*CTC061 WS Aware Monitor*

*770067 WS Aware Monitor*

## Differences Between Models CTC061 and 770067

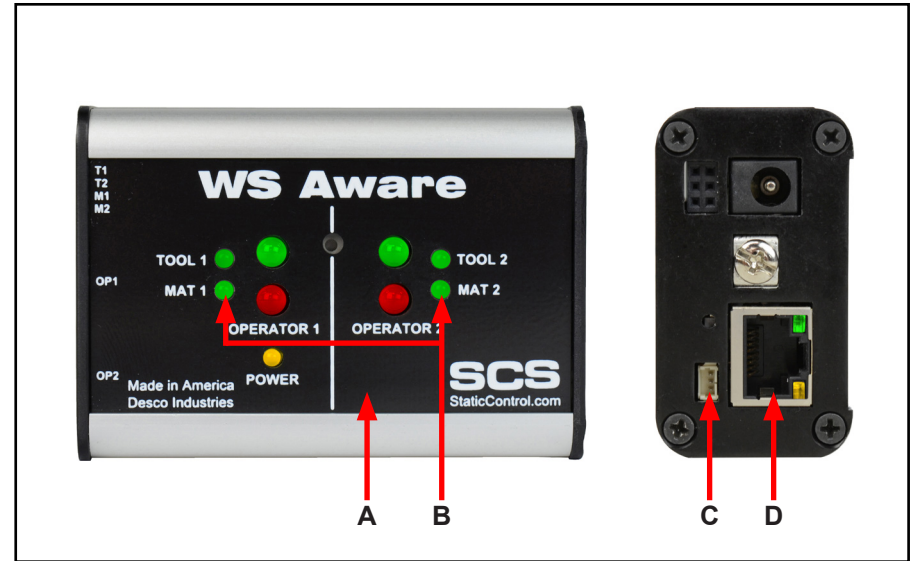
A. Black face plate with new labeling for Tool, Mat, and Operator circuits.

B. Mat default test limit is set to 100 megohms. It may still be configured up to 1 gigohm via SMP.

C. New terminal for use with the SCS 770069 Power Relay accessory.

D. Connector with 4.20 mA output and optical relay terminal replaced with Ethernet jack that provides network communication between the WS Aware Monitor and Static Management Program (SMP).
